SUNDRY NOTICES AND REPORTS ON WELLS
Do not use this form for proposals to drill or to re-enter an abandoned well. Use Form 3160-3 (APD) for such proposals.

JAN FEDERAL #1

30-005-64154

SCHEMATIC PRIOR TO PLUG AND ABANDON
JALAPENO CORPORATION
JAN FEDERAL NO. 1
CHAVES COUNTY, NEW MEXICO
API NO. 30-005-64154

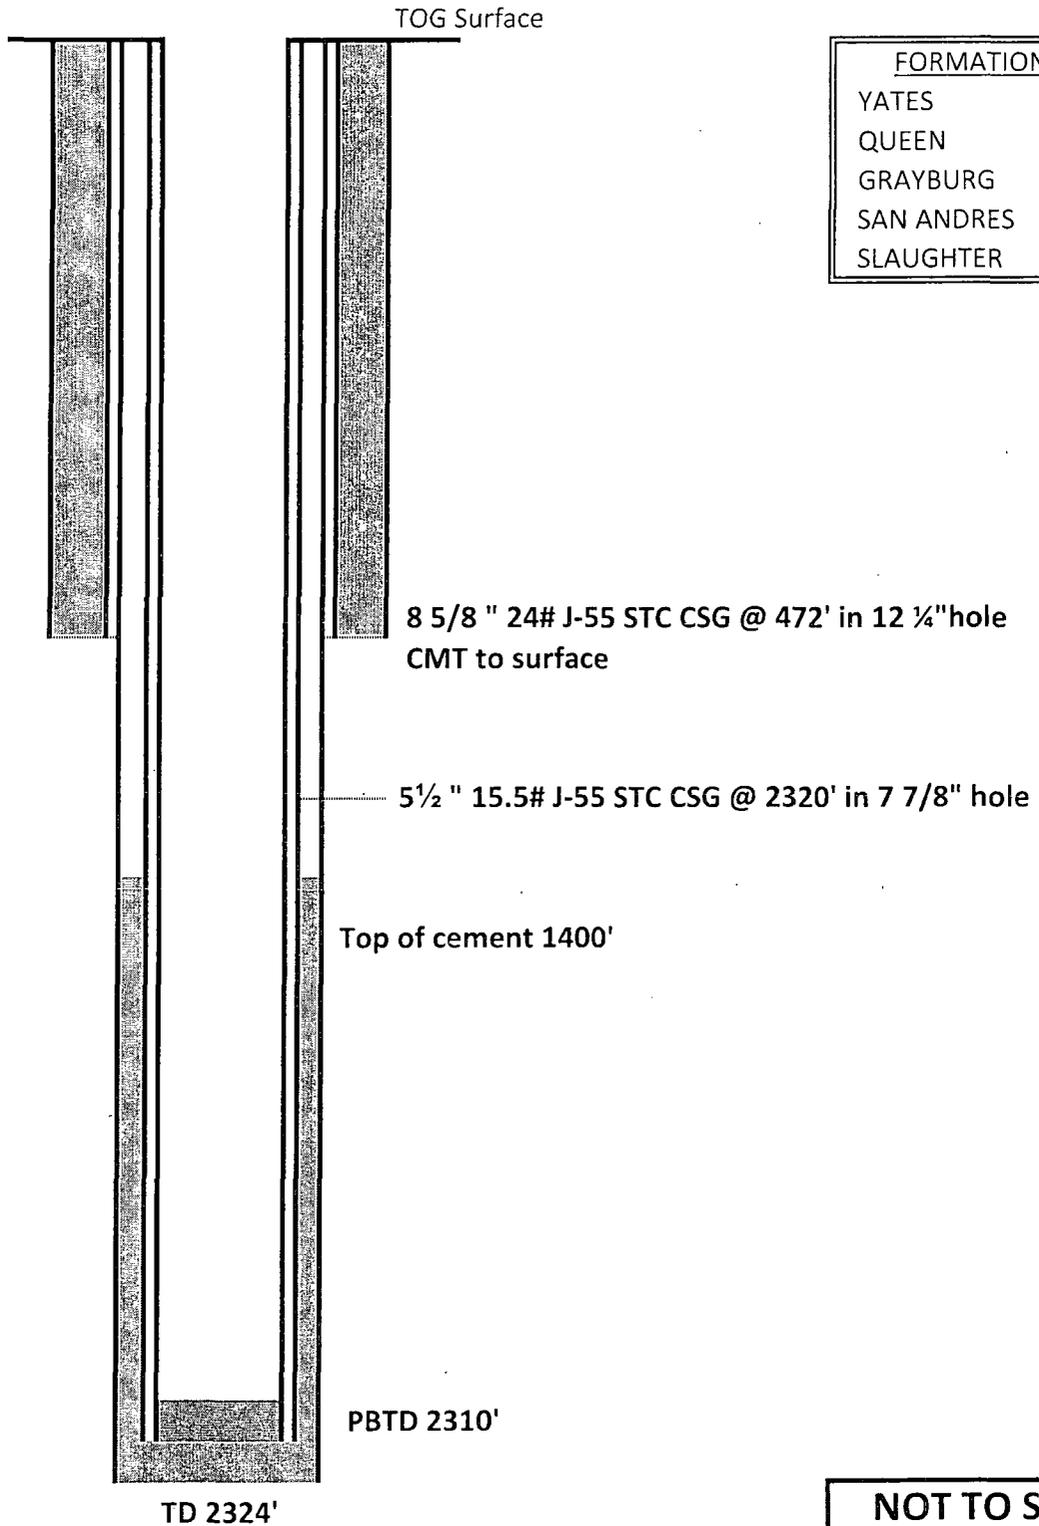
1. Set a 25 sack Cement Plug from PBTD (we did not perforate the casing).
2. Wait for cement to dry and tag. *e Or Above 2210' - Witness*
3. Fill hole with mud 50 feet below Surface Shoe.
4. Perforate 50 feet below Surface Shoe and *circulate* cement *From 522' To Surface*.
5. Wait for cement to dry.
6. Set dry hole marker.
